MODBAR TECHNICAL BULLETIN #27 AV tap LED board

We would like to inform you that the AV tap LED board has been re-designed with more efficient electrical insulation to improve its reliability.

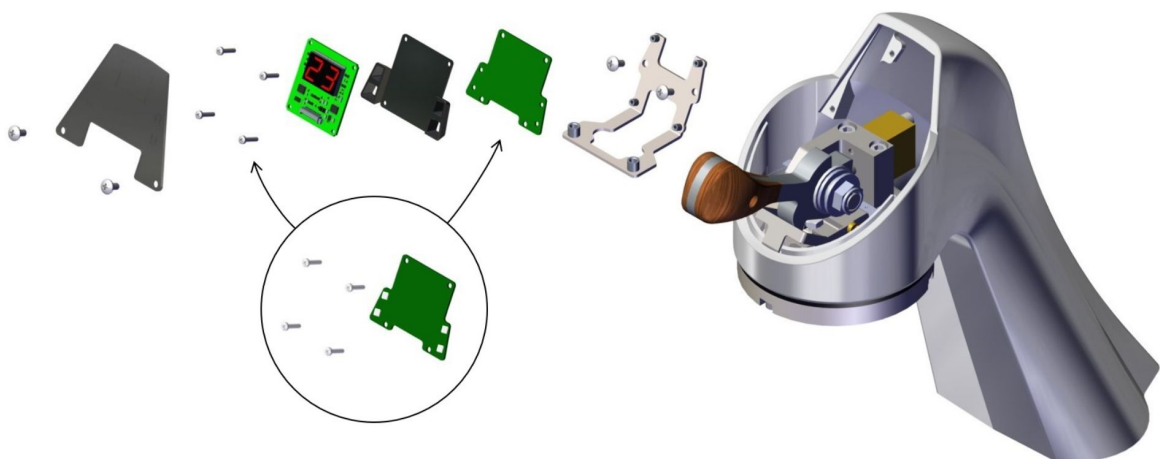
In addition to the new electronic board, the 4 screws which secure it to the bracket have also been substituted with plastic ones.

This modification comes after examining a few issues that have occurred where the LED board stopped working for apparently no reason, giving a "low voltage error" on the module's display. We discovered that the previous LED board E.1.049 was likely to short circuit due to overtightening of its screws, as well as, strong vibrations during transportation or excessive pressure applied onto the display.

Should you experience the same problem, we suggest that you substitute the LED board and screws with the new ones.

This modification takes effect from serial numbers AV00003131 and AVT00013088 (extra tap).

The new board is already available for order from Nuova Ricambi with code E.1.049.R.
It comes in a kit with its 4 plastic screws, which can also be purchased individually with code I.6.016.
